**CITY OF WINTERS PLANNING COMMISSION AGENDA  
SPECIAL MEETING**

- A. Continued from May 28, 2013, Public Hearing and Consideration of Approval of Taco Bell/Dog Park project located at 701 Matsumoto Lane, APN 038-050-063:
  - a. Modification of Conditional Use Permit Eliminating the Proposed Truck Fueling Station and Adding a Dog Park
  - b. Site Plan/Design Review
  - c. CEQA Exemption under Section 15183 of the CEQA Guidelines

## PLANNING COMMISSION STAFF REPORT

- Modification of Conditional Use Permit (CUP)
- Approval of Revised Site Plan/Design Review
- CEQA Clearance

STREETSCAPE ALONG MATSUMOTO LANE

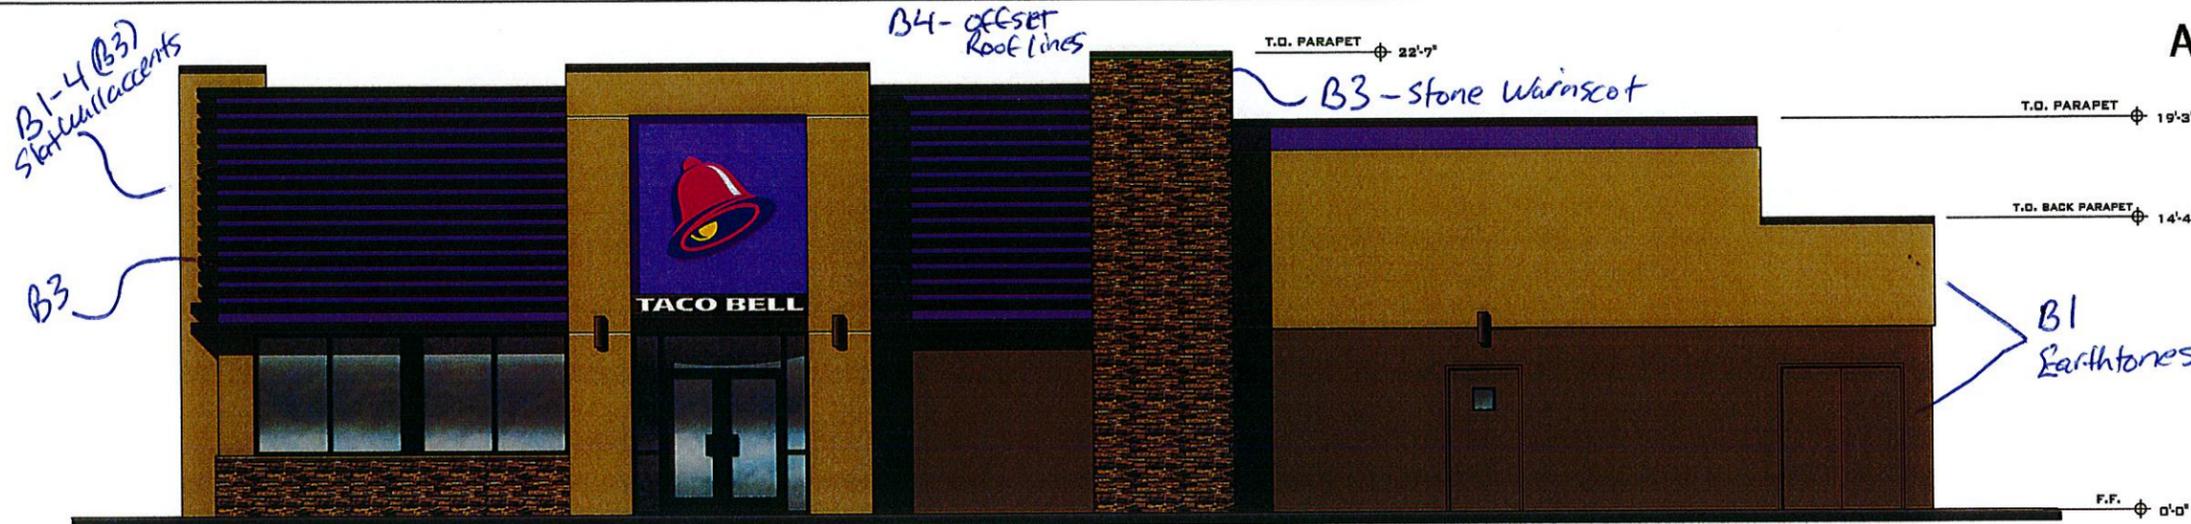
- *Complete lush localized landscaping used for BK project through the rest of the site. Will use species from previous design.*
- *Will research best landscaping for dog park.*
- *Based on Planning Commission comment they may lessen the trees in front of the Taco Bell building along Matsumoto so as to not hide the building.*
- *Ornamental grapevines with posts and cable suggested for along the drive through area.*

**EAST ENTRY ELEVATION**

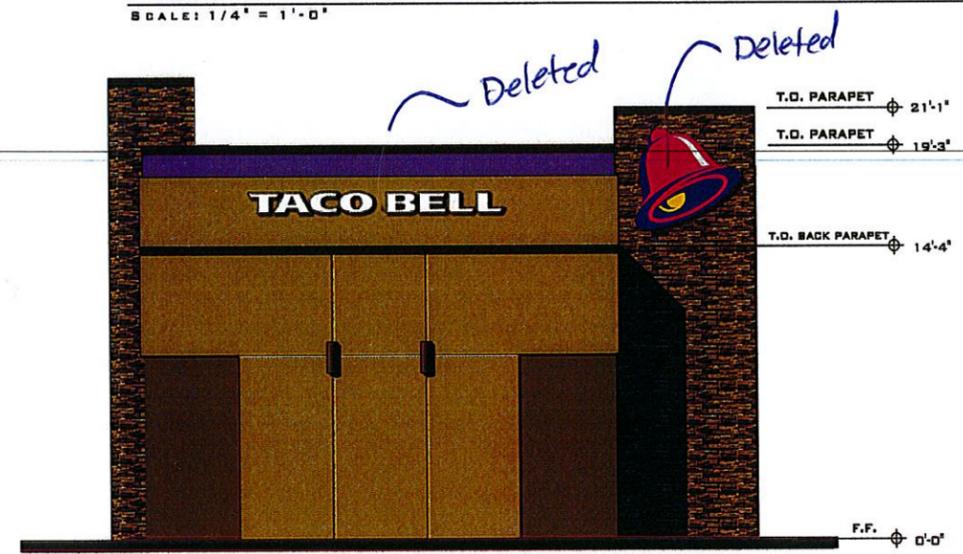
Notes  
 E1 - Signage on only 2 sides  
 E1 - Monument sign removed

64. Pursuant to Winters Municipal Code Section 17.80.040, the building elevations showing the wall signs shall be modified to show wall signs on the south and east elevations only and limited to a maximum total sign area of 100 square feet, to the satisfaction of the Community Development Director.
